Product Change Notice

Design related: minor design change of port-plug

Port-plug used for AFBR-5978Z, QFBR-5978Z

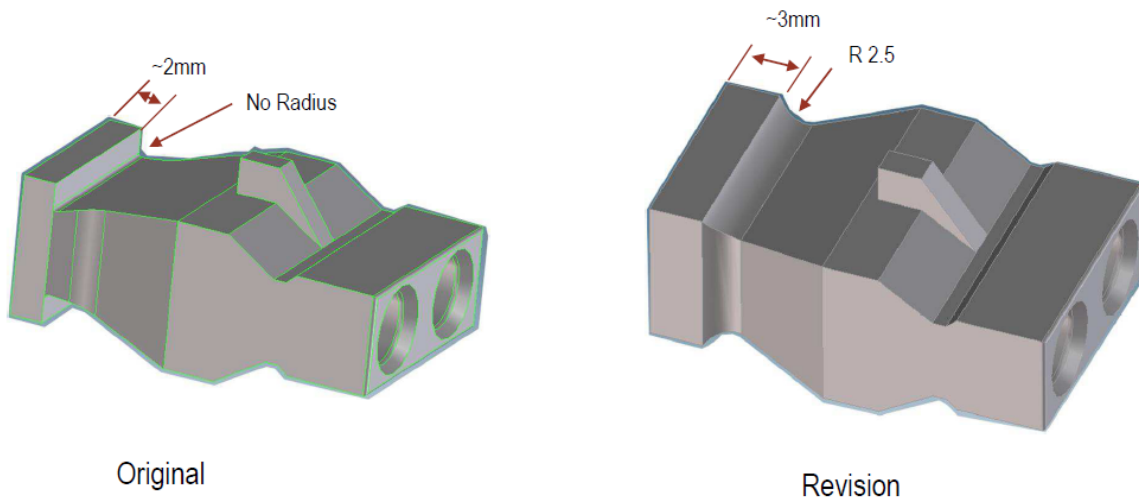
Additional radius at port-plug, details see below pictures. The port-plug material is unchanged.

Additional radius will improve ruggedness of port-plug and therefore improve the mechanical stability and reliability.

Only a visual noticeable change in the design of the port-plug. No effect on the de-plugging force of the port-plug or on product electrical performance.
